Proposed Radiological Environmental Technical Specifications

POWER AUTHORITY OF THE STATE OF NEW YORK  
INDIAN POINT 3 NUCLEAR POWER PLANT  
DOCKET NO. 50-286  
September, 1983

Proposed Appendix A  
Technical Specification Changes

MAP DEFINING UNRESTRICTED AREAS FOR RADIOACTIVE GASEOUS AND LIQUID EFFLUENTS \*  
FIGURE 5.8-1

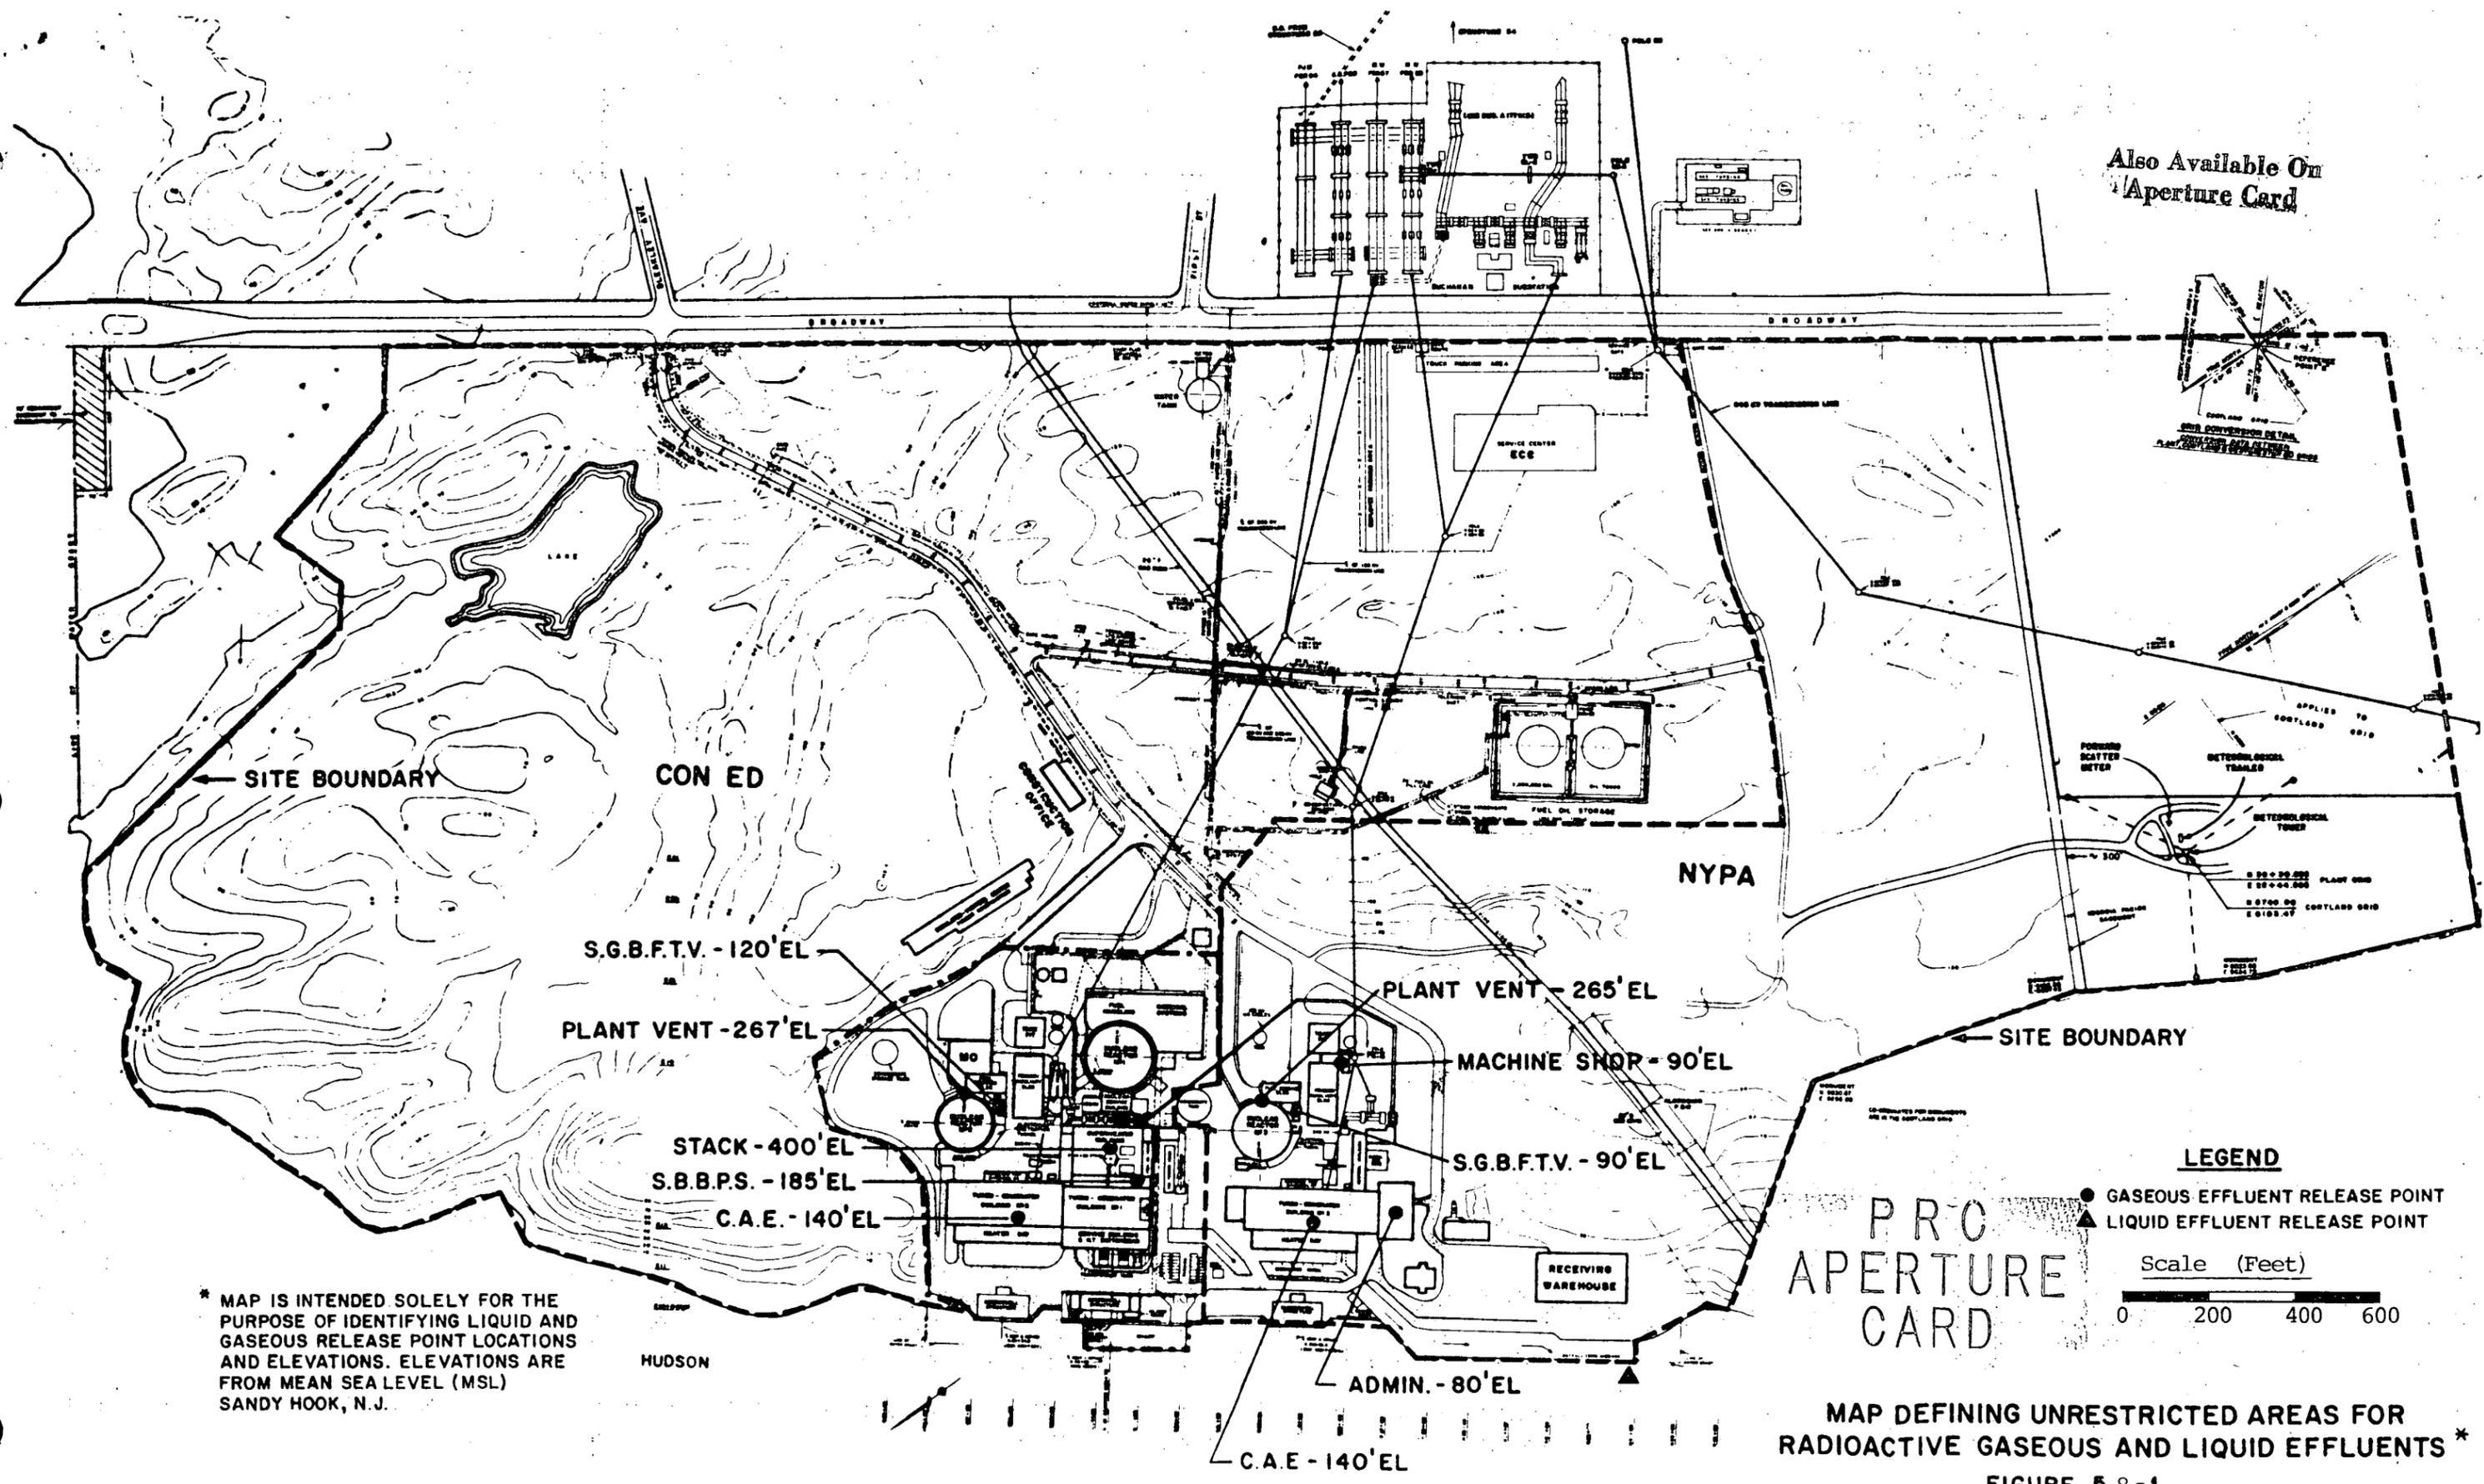
Information regarding radioactive gaseous and liquid effluents, which will allow identification of structures and release points as well as definition of UNRESTRICTED AREAS within the SITE BOUNDARY that are accessible to MEMBERS OF THE PUBLIC, shall be shown in Figure 5.8-1.
